SPECIAL USE REPORT

▶ **FILE #:** 4-D-23-SU **AGENDA ITEM #:** 10
 POSTPONEMENT(S): 4/19/2023 **AGENDA DATE:** 5/11/2023
 ▶ **APPLICANT:** TACO BELL OF AMERICA, LLC (ROBERT SULLIVAN)
 OWNER(S): Peoples Development Company, Inc. Peoples Development Company, Inc.

▶ **ZONING:** C-G-1 (General Commercial)
 ▶ **EXISTING LAND USE:** Commercial
 ▶ **PROPOSED USE:** Restaurant with drive-through facility

STAFF RECOMMENDATION:

C-111

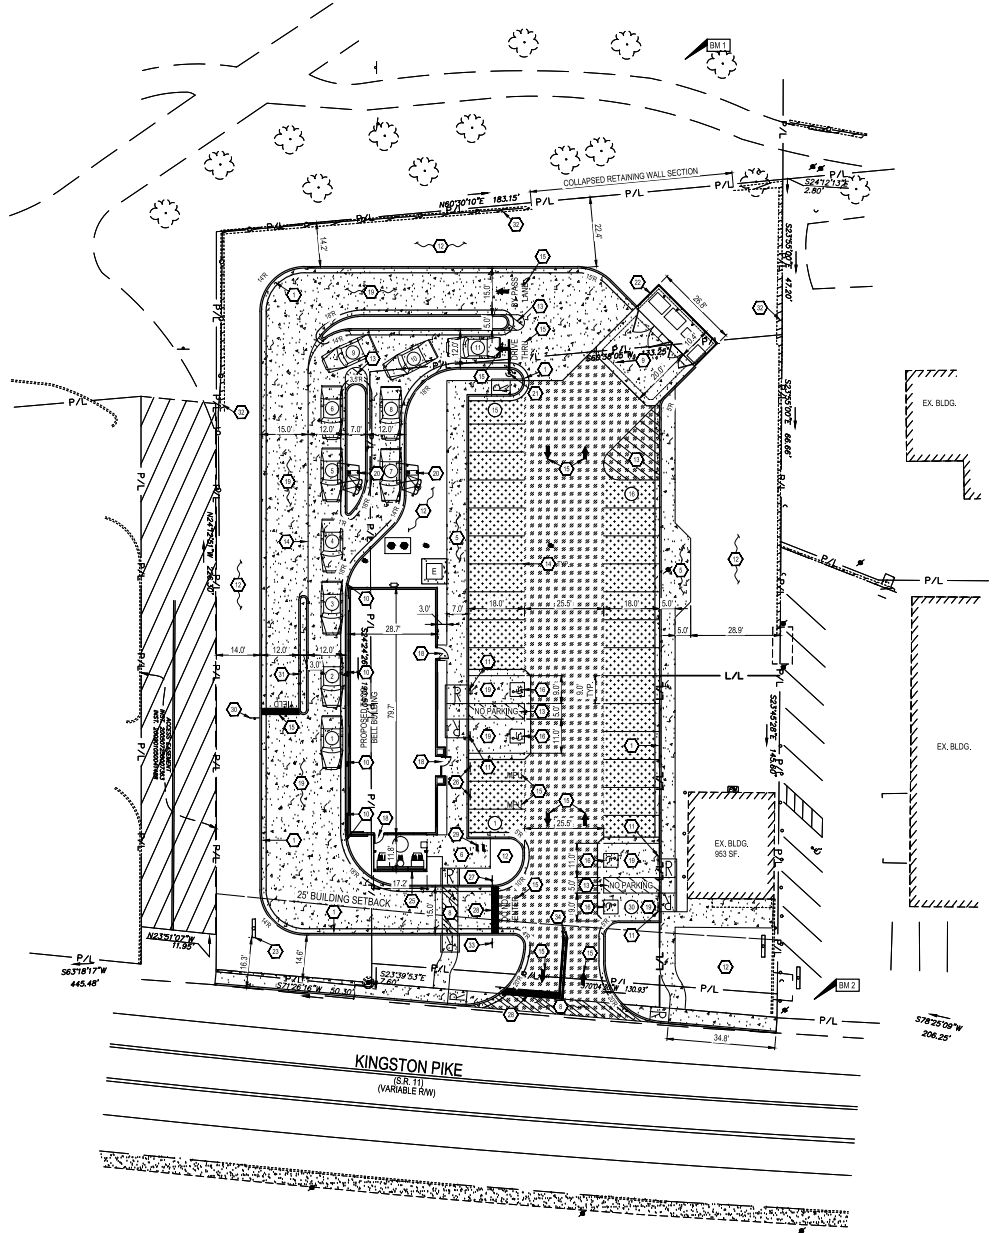
This is a proposal to construct a drive-through facility for a new restaurant at this site. There are two existing structures; a large multi-tenant commercial building and a small single-tenant building. The larger building is proposed to be demolished, and the new parking lot will accommodate parking for the small commercial building as well as the new restaurant. The parking between the small building and Kingston Pike can be removed.

To the rear of the subject site are the Bearden Elementary School campus, Bearden Village Greenway, and the Century Court / Westwood residential neighborhoods. The subject site is approximately 10 ft lower in elevation than the referenced uses to the rear, which will help buffer the drive-through use from those properties. In addition, the principal use standards for drive-through facilities require a Class B buffer yard and a 6 to 8-ft tall opaque wall or fence when abutting a residential district, a public park, or a primary or secondary educational facility. The lower site and the required landscape buffer yard and fencing will help lessen nuisance issues from light and noise to nearby properties.

C. The subject site is approximately 10 ft lower than the properties to the rear, and a Class B buffer yard and opaque fence or wall are required along the rear lot line and a portion of the west lot line.

- ▶ **Approve the request for a drive-through facility in the C-G-1 zoning district, subject to 6 conditions.**
1. Meeting the requirements of principal use standards for drive-through facilities (Article 9.3.F) of the City of Knoxville Zoning Ordinance.
 2. Meeting the requirements of Article 13 (Signs) of the City of Knoxville Zoning Ordinance.

3. Installation of landscaping per the requirements of Article 12 (Landscaping) of the City of Knoxville Zoning Ordinance, including the Class B buffer yard required by the principal use standards for drive-through facilities (Article 9.3.F.5). The proposed landscape plan requires Alternative Landscape Design (ALD) approval because the required 20 ft width is not provided in all locations where it is required. If the ALD is not approved, the site design must be modified to accommodate the required buffer width and may require a new Special Use approval if the site design changes significantly.
4. Meeting all applicable requirements of the Knoxville Department of Engineering.
5. Meeting all applicable requirements of the Tennessee Department of Transportation.
6. Meeting all other applicable requirements of the City of Knoxville Zoning Ordinance.
